Nancy and I came up with these signage options after the meeting to address a few concerns regarding where to place the signs below. This is a quick abstract summary -Please send comments to Jim Fisher and feel free to contact me if you have a question about the ideas/locations.

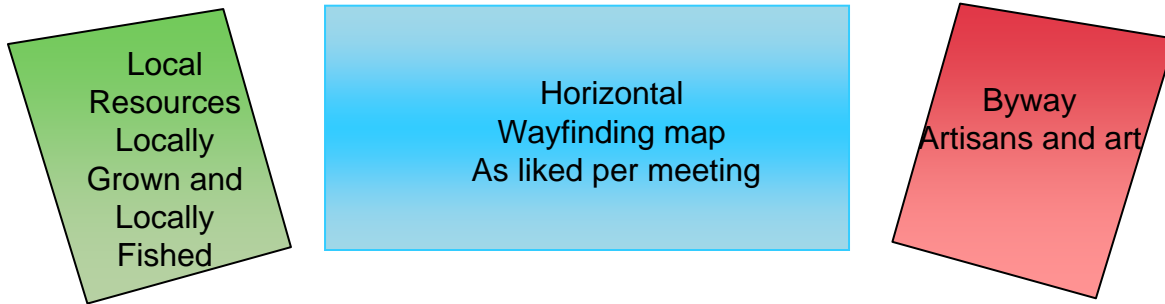
A. 4'6 x 2' Behind Rock at Gateway Site

B. 2- 2'x2' Frenchman Bay Overlook

3 panels in arc behind rock at gateway
2- 2'x2' and 4'x2'

D. Replace, replacement lobster panel At Frenchman Bay Overlook
